PUBLIC BUILDING COMMISSION OF CHICAGO
50 WEST WASHINGTON STREET, CHICAGO, IL 60602
12th DISTRICT POLICE STATION
1412 SOUTH BLUE ISLAND AVENUE, CHICAGO, IL 60608

DESCRIPTION: UPDATED INTERIOR ELEVATION
REVISION: ADDENDUM 1

SHEET:
ASK.01

Sketch No.
PSK-03

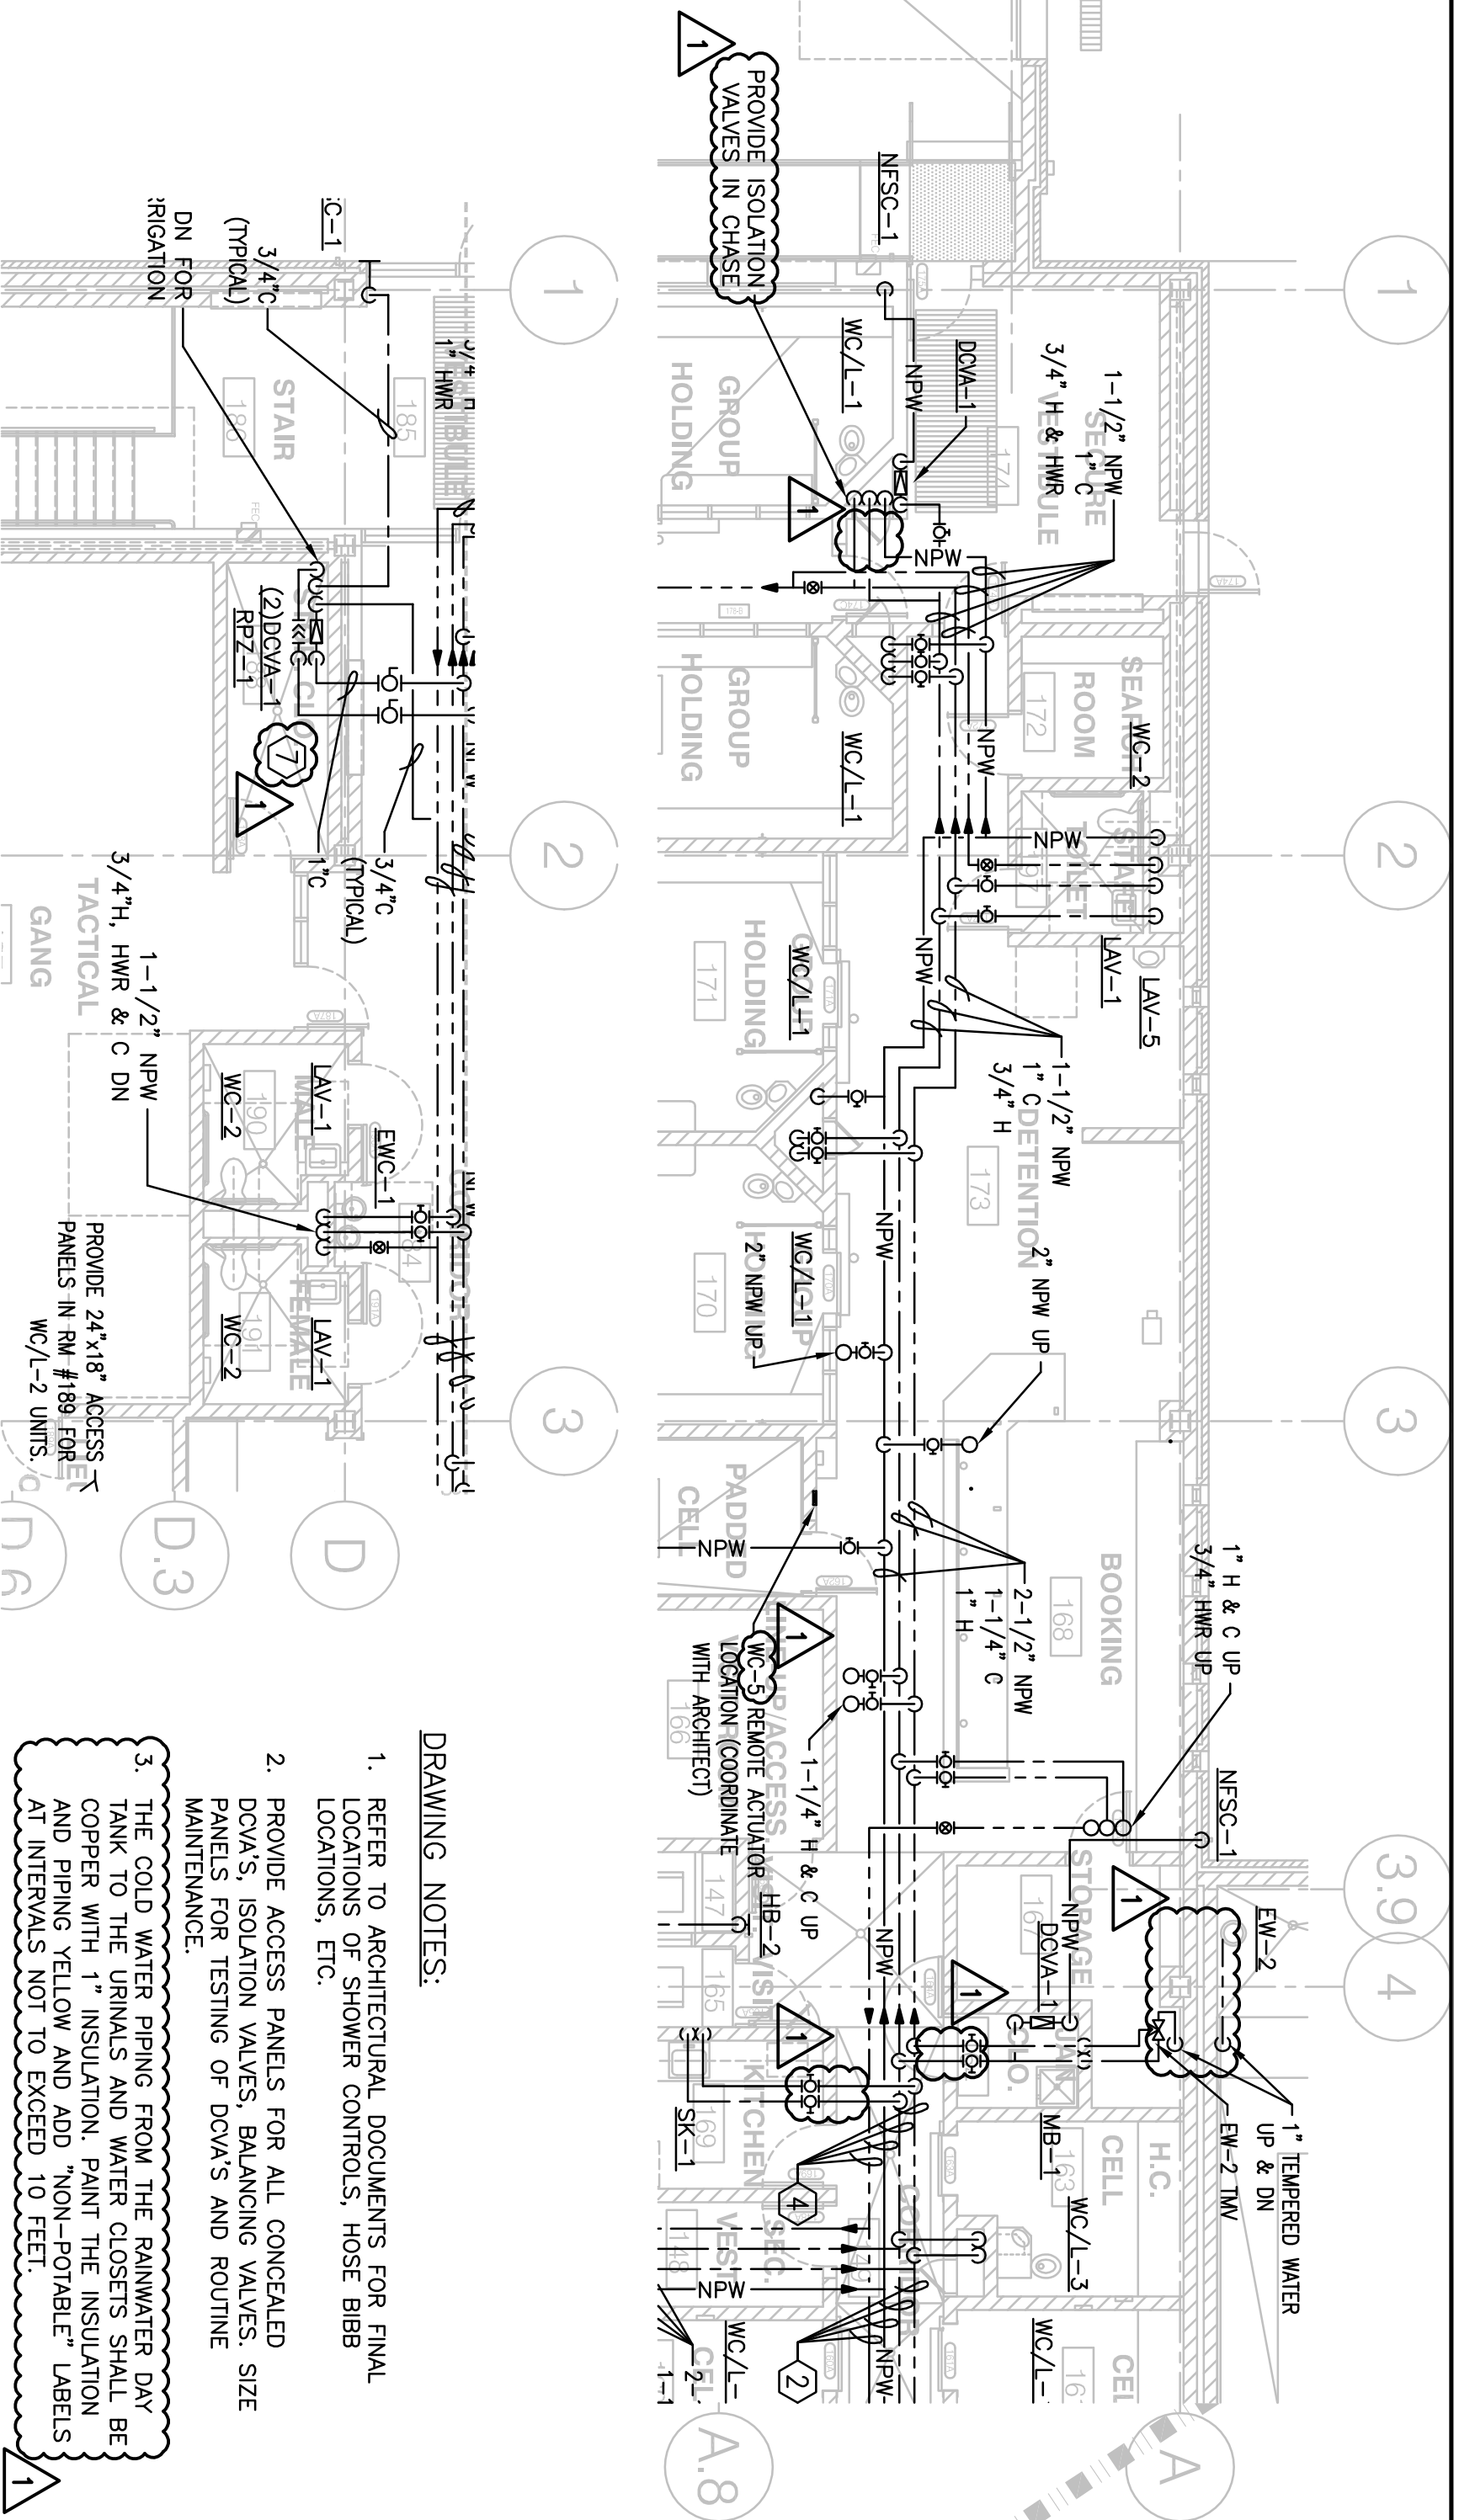
PROVIDE ISOLATION VALVES IN CHASE

3. THE COLD WATER PIPING FROM THE RAINWATER DAY TANK TO THE URINALS AND WATER CLOSETS SHALL BE COPPER WITH 1" INSULATION. PAINT THE INSULATION AND PIPING YELLOW AND ADD "NON-POTABLE" LABELS AT INTERVALS NOT TO EXCEED 10 FEET.

1 REFERENCE DRAWING: P0.0 (PLUMBING NOTES, ABBREVIATIONS, AND SYMBOLS)
SCALE: N.T.S.

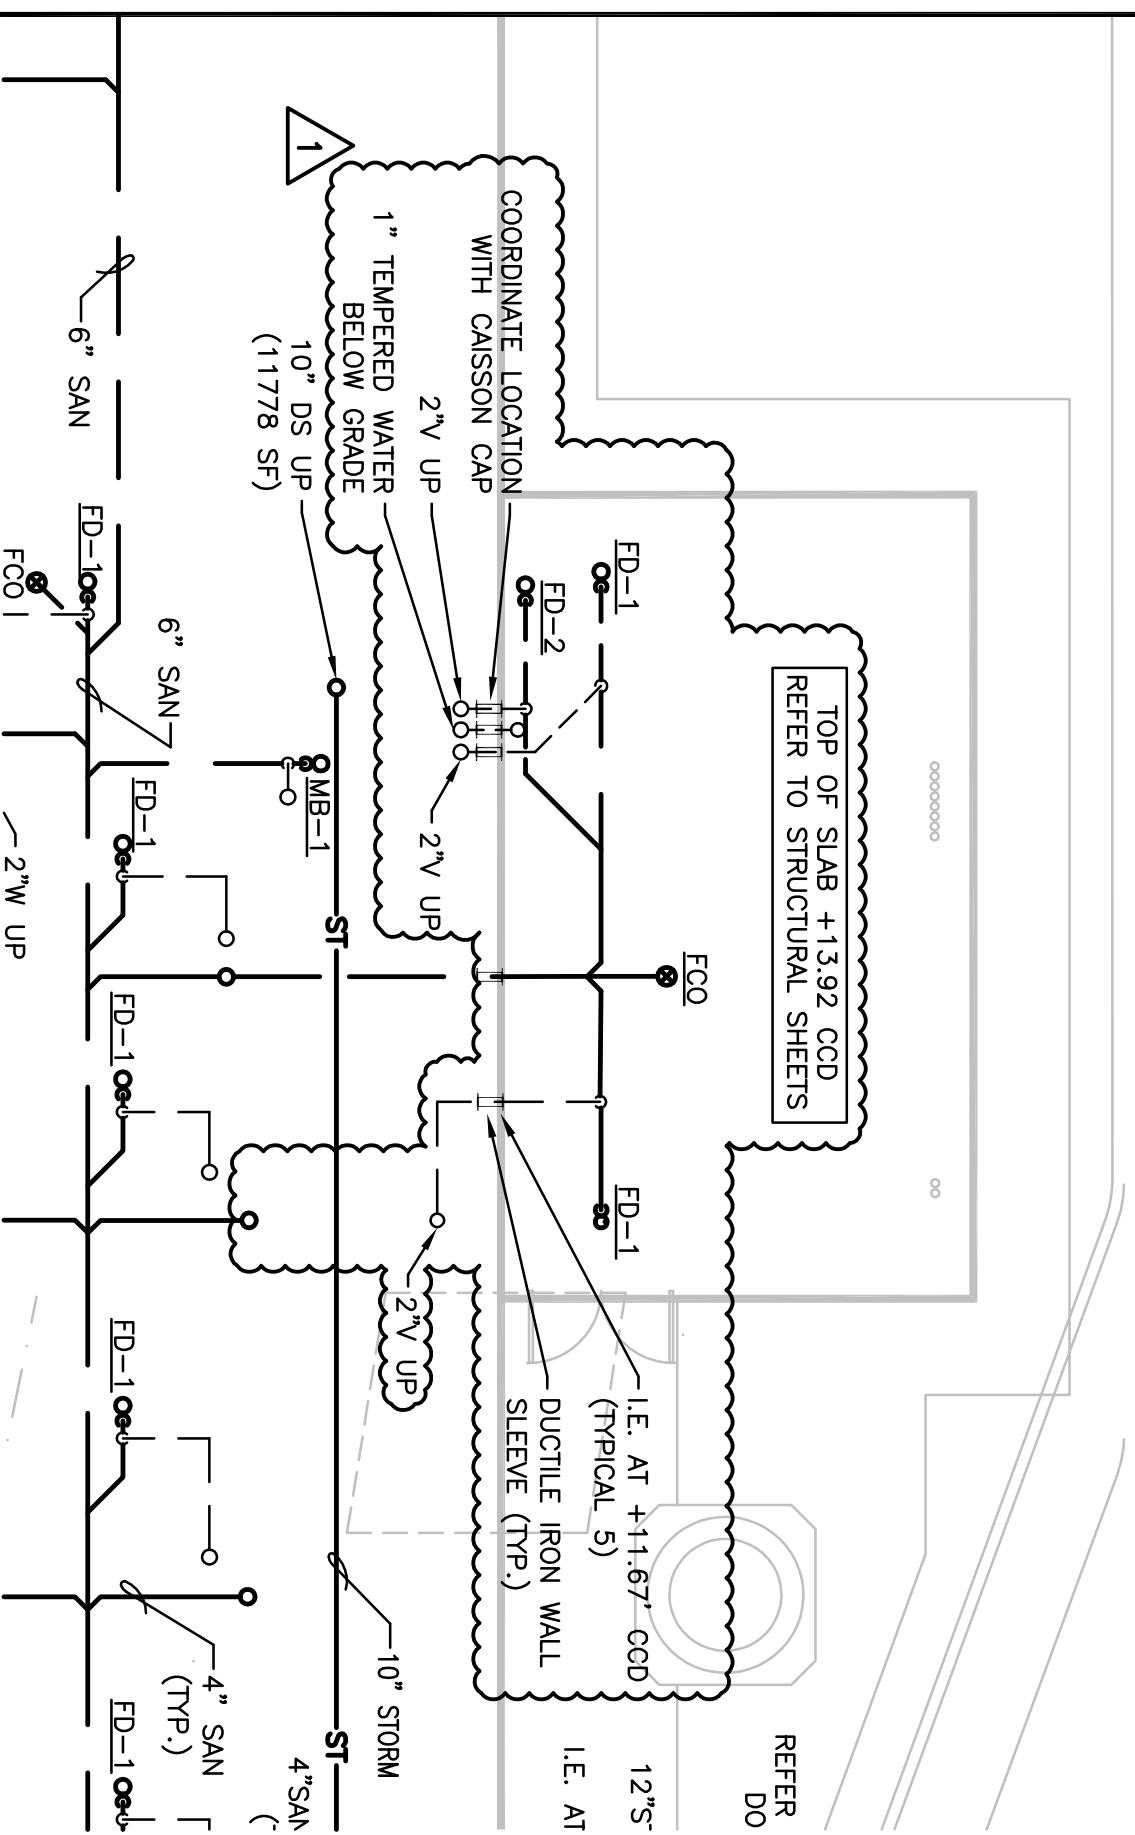
19. THE HARVESTED RAINWATER NON-POTABLE WATER SUPPLY DISTRIBUTION PIPING AND INSULATION SHALL BE PAINTED YELLOW, AND THE INSULATION MUST BE MARKED "NON-POTABLE" AT INTERVALS NOT TO EXCEED TEN FEET.
